Planning App Ref:	PL/2026/02177
Service Ref:	Drainage
Date:	20 April 2026

Prior Approval Part 3, Class MA: Commercial, business and service uses to dwellinghouses:
Conversion of building into 6 flats comprising 3 x 3 beds and 3 x two beds - No external changes to the external facades is anticipated

Boreham Mill, Bishopstrow Road, Warminster, Wiltshire, BA12 9HQ

Figure 1

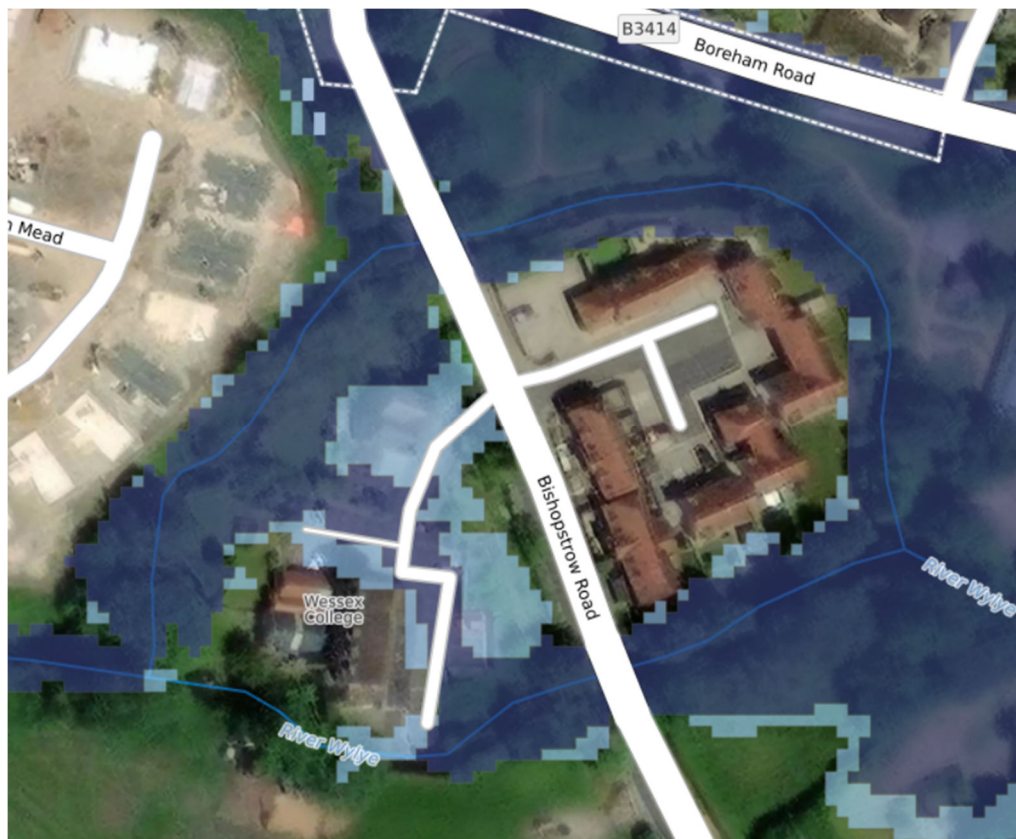
A review of the EA RoFRS (Figure 1) shows that when considering the impacts of climate change, the flood polygons overlap the building footprint indicating that the site will be at risk of fluvial flooding in the future and would be completely cut off by Fluvial Flooding during an event.

As a result of the increase in flood vulnerability (due to the change to residential properties), a full and detailed FRA should be completed:

There is a greater flood vulnerability being introduced through the change to residential property, we would expect the applicant to complete an assessment of the flood hazard rating to demonstrate that safe access and egress can be maintained during the design flood as per PPG 047 (How can you ensure acceptable emergency planning provision).
